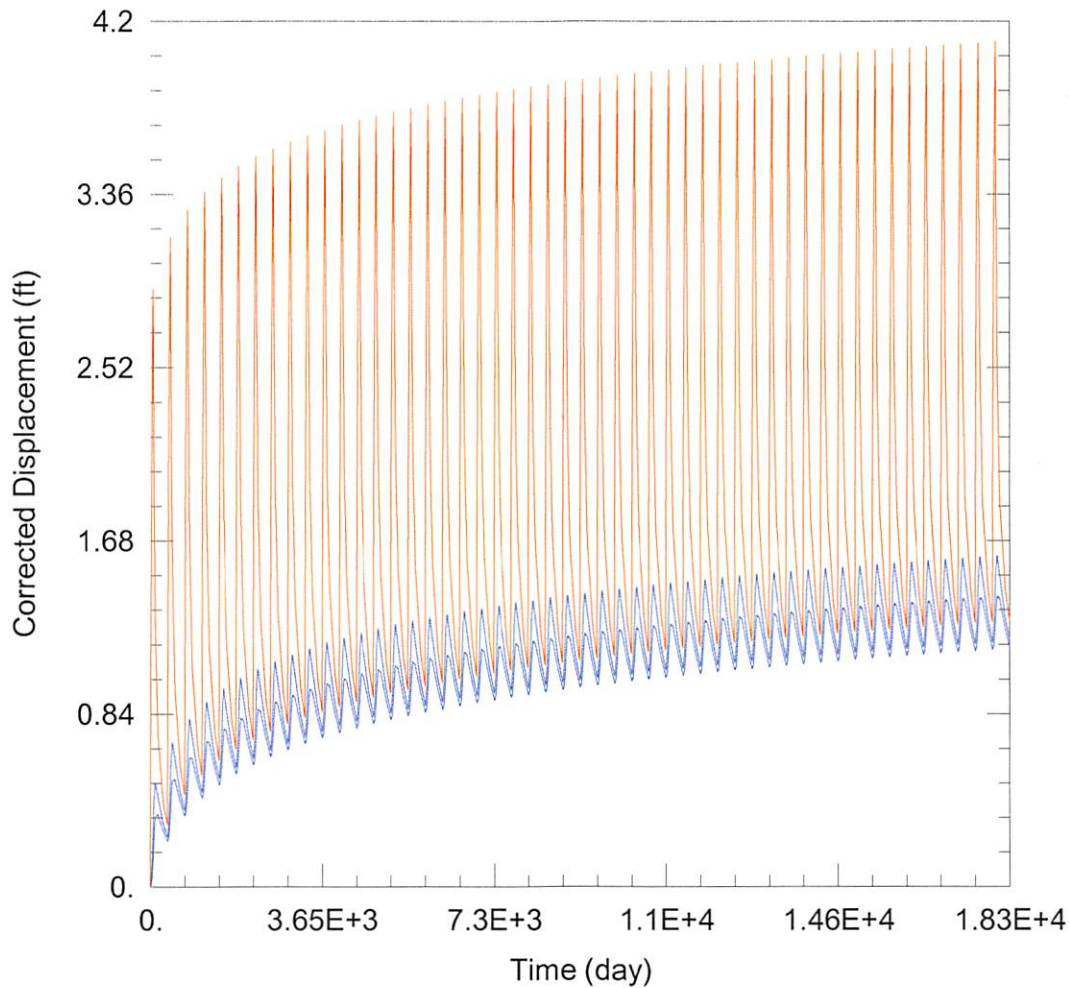
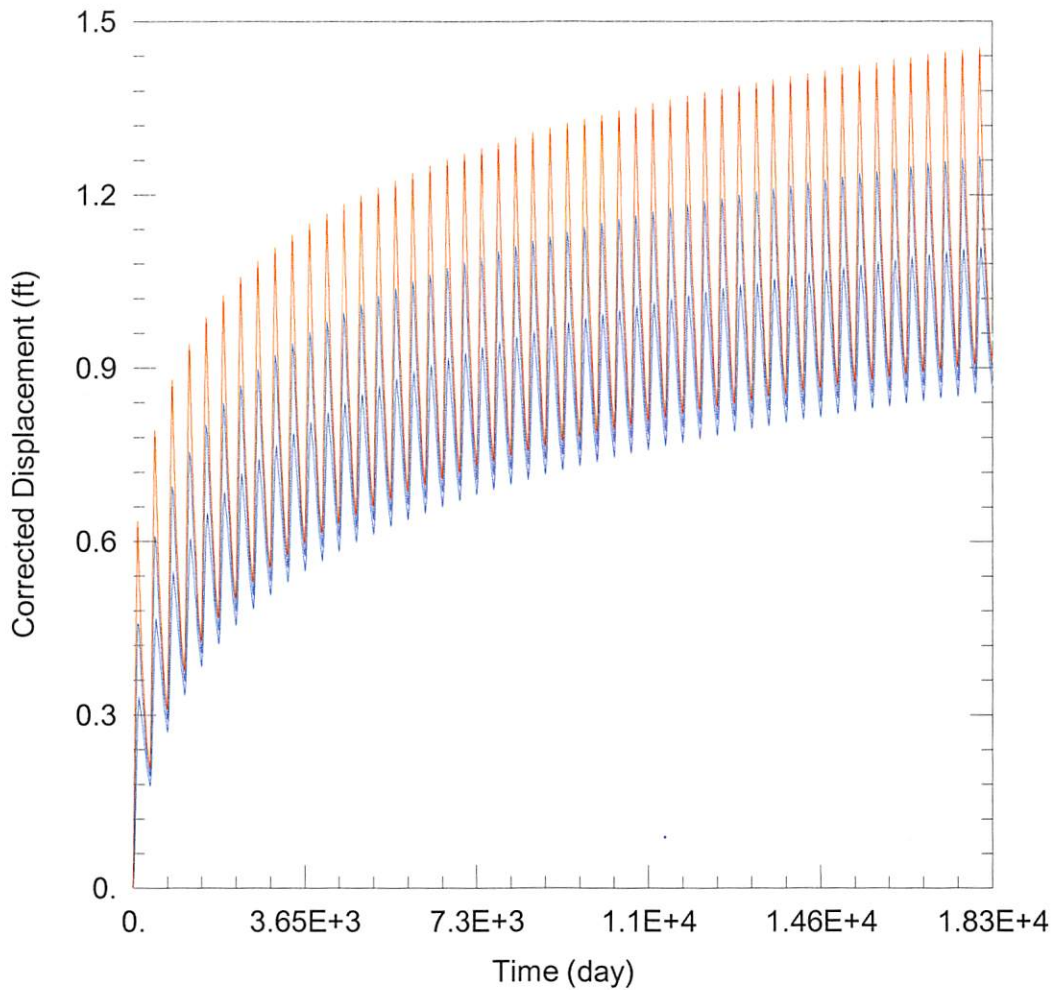
Domestic: Drawdown from current location = 1.45 ft
 Drawdown from proposed location = 4.10 ft
 Net drawdown = 2.7 ft

Net drawdown does not exceed the drawdown allowance of 4.0 ft for any well located within 1 mile of the proposed point of diversion, so no further analysis is necessary.

The proposed change is unlikely to have more than a negligible effect on neighboring wells, based upon the aquifer characteristics shown in the GMD3 model and local aquifer saturated thickness. GMD3 staff recommends approval of this application.
